23 VISUAL AMENITY

23.1 DESALINATION PLANT

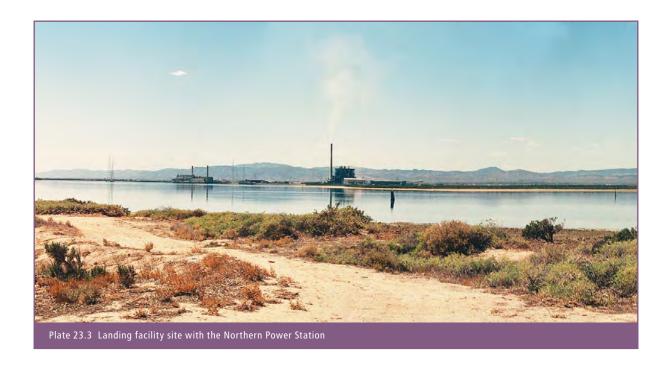
It was suggested that the access corridor and landing facility would reduce the visual amenity of the region. Confirmation was also sought on the proposed hours of operation and any associated light spill from night-time operations. It was also asked whether the viewpoints investigated for the visual assessment were consistent with the most immediate receptors.

The impact of the access corridor and landing facility on the visual amenity of the local area has been assessed as being from 'slight' to 'substantial', depending on the proximity of residences to the facilities (refer Chapter 20 and Appendix R of the Draft EIS for details). It is proposed that shipping to the landing facility and operation of the associated quarantine laydown area (as shown on Plate 23.3) would occur during daylight hours only. Lighting at these facilities would be installed for security purposes only, and would be low-intensity directional lighting. This has no anticipated significant impact on the area. Visual assessments were conducted from sensitive viewing locations including roads and residences nearest to the proposed facilities. In order to minimise this impact, tree planting would be used to screen the access road, using native species common to the Upper Spencer Gulf area.

Ships and barges were not included in the visual assessment of the landing facility as they were considered to be too transient to significantly influence the assessment outcomes (i.e. on average, one vessel visiting the facility every 11 days).

Plate 23.5 Viewpoint 10 showing the proposed rock storage facility (left) and tailings storage facility (right) from Arid Recovery viewing platform – 50 mm lens photomontage (human field of view)

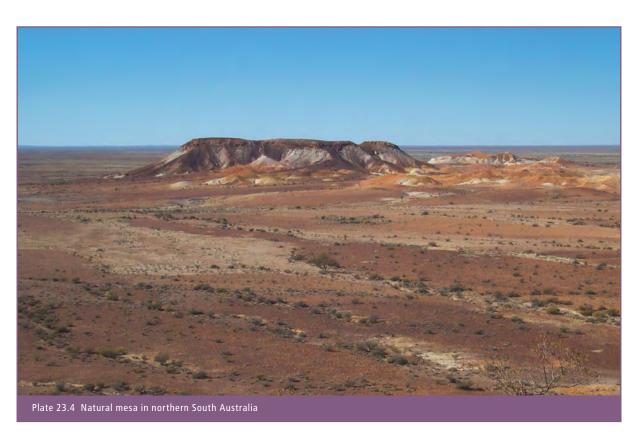
BHP Billiton was asked to provide a discussion comparing the visual impact of the proposed landforms of the rock storage facility (RSF) and tailings storage facility (TSF) with possible other, more natural landform shapes.

As described in Section 20.5.1 of the Draft EIS, the flat-topped RSF and TSF would resemble the natural, steep-walled mesas that occur in northern South Australia (see Plates 23.4 and 23.5 of the Supplementary EIS).

The wall angles of RSF and TSF have been designed to ensure the security of these facilities and eliminate the risk of slippage or failure. Therefore, the design of the landform has engineering as well as aesthetic imperatives. Increasing the wall angle would compromise the structural integrity of these structures, whereas decreasing the batter angle to make a flatter shape, or reducing the structures' design height would increase the land area required for their construction and increase their overall impact on the surrounding area.

The final design has achieved an optimal combination of aesthetic imperatives and engineering requirements to minimise footprint, maximise stability and develop a mesa-like landform structure.
